PCN-20190826 TE0703-06 Under Voltage Protection Change

Company	Trenz Electronic GmbH
PCN Number	PCN-20190826
Title	TE0703-06 Under Voltage Protection Change
Subject	Trenz Electronic TE0703 Hardware Change
Issue Date	2019-09-05

This change affects TE0703 carrier of revision TE0703-06 with serial number greater than 571113

#1 Replaced R31 by 953kOhm and R35 by 147kOhm

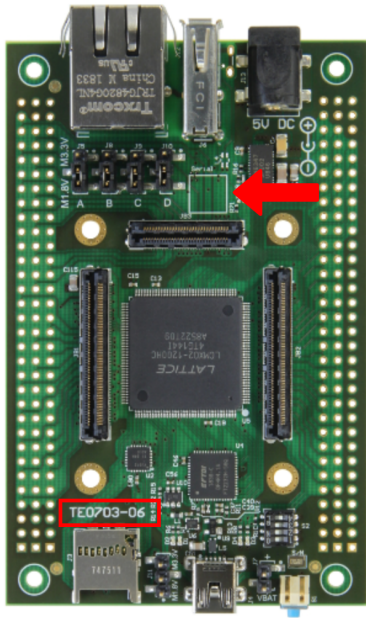
Reason: Large start up currents led due to adverse conditions (e.g. weak powersupply, long wires, increased contact resistance) to a voltage drop below the under voltage lock out limit of the input protection circuit.

Impact: Under voltage protection limit is decreased to 4.06V, which gives a larger margin for a voltage drop during start up.
